Product Change Notification

PCN-PCC-7815-2022

Business Unit	Product Line Code	Type of Change	Action	Date of Issue
PCC - PCB Connectors	AAC	Product Change Notification	Notify Distributors and Field	3/28/2022

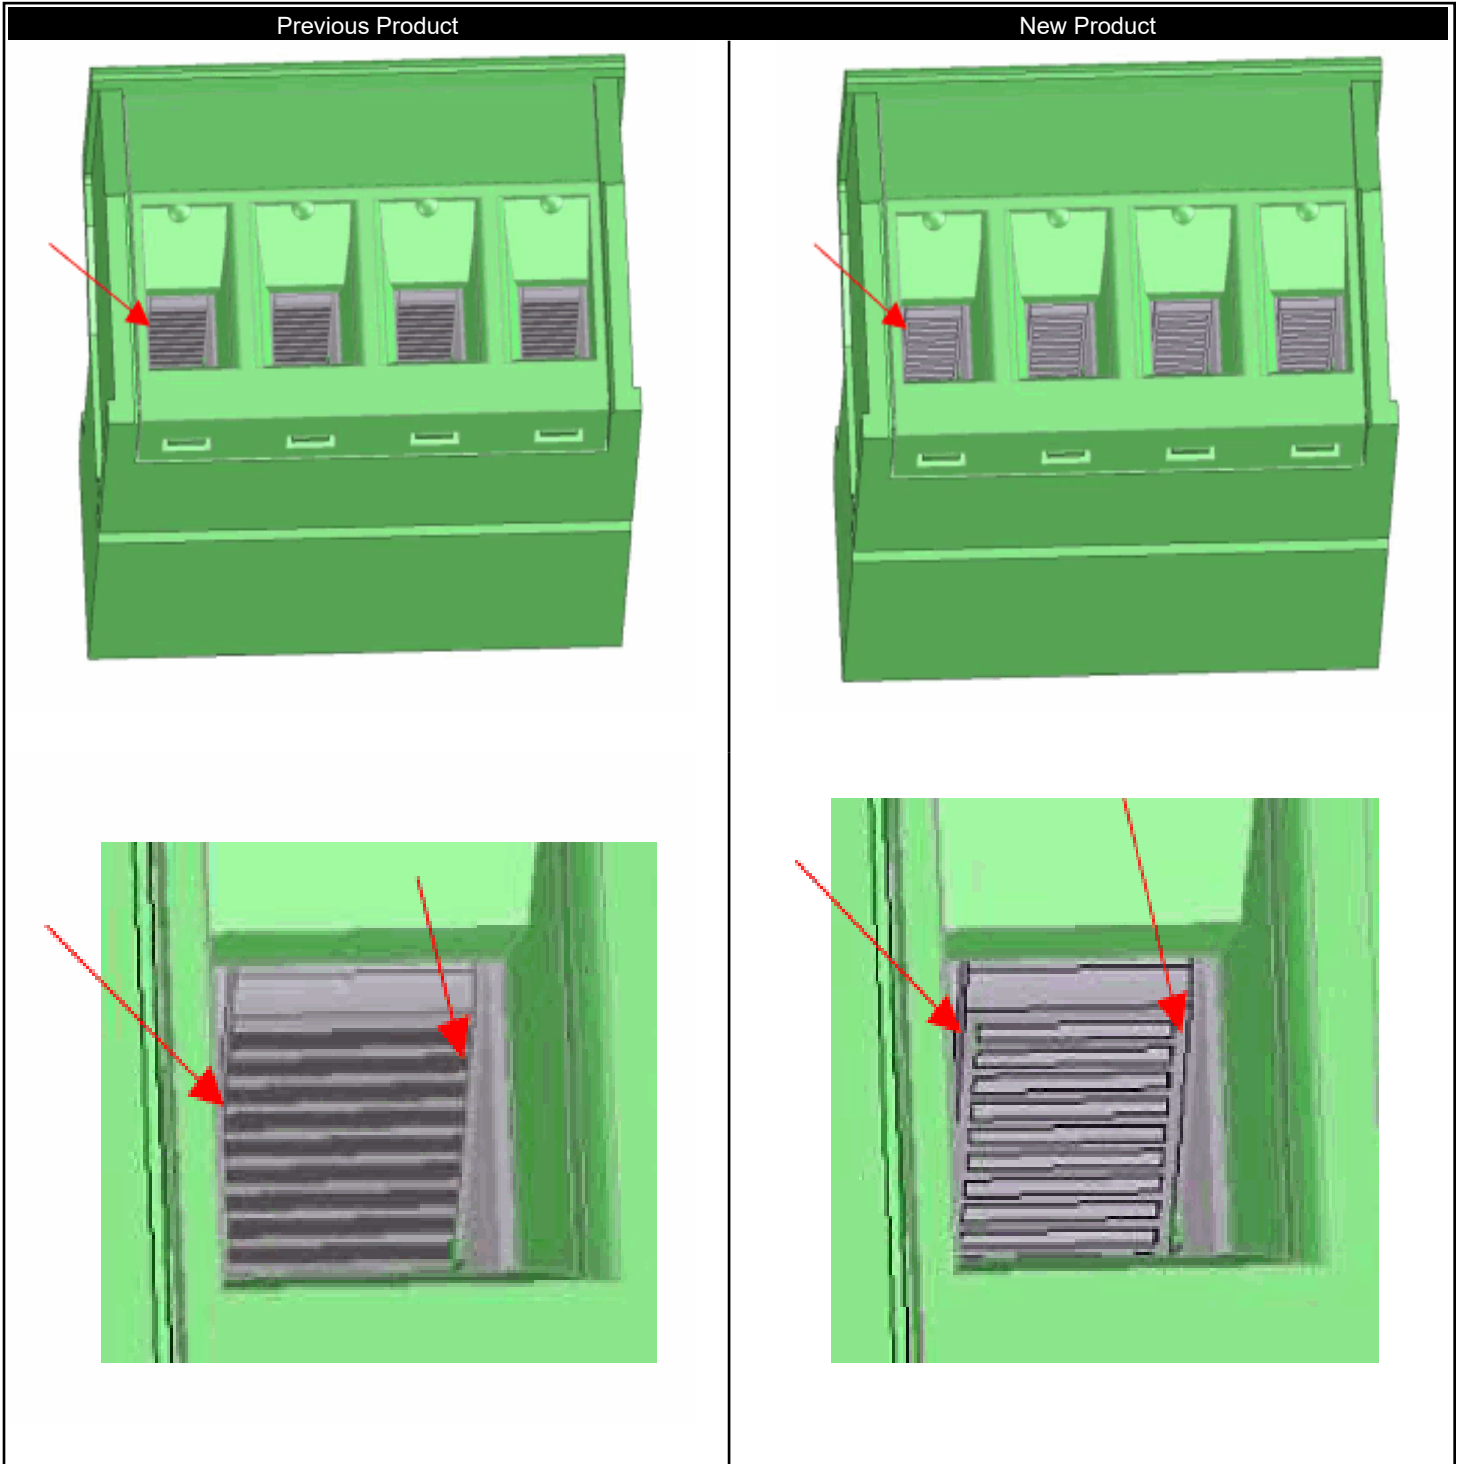
Description for Product Change Notification
In order to optimize the manufacturing processes for parts within the (G)IC 2,5/...-ST(G)(F), DFK-MSTB 2,5/...-STF and (U)MSTBHK 2,5 series, the current bars will have a thin, continuous bridge on the outer edges without fluting in the area of the conductor connection. A visual comparison of old/new is provided in the attachment. The change has no effect on the technical properties of the item. The batch number will not be increased.
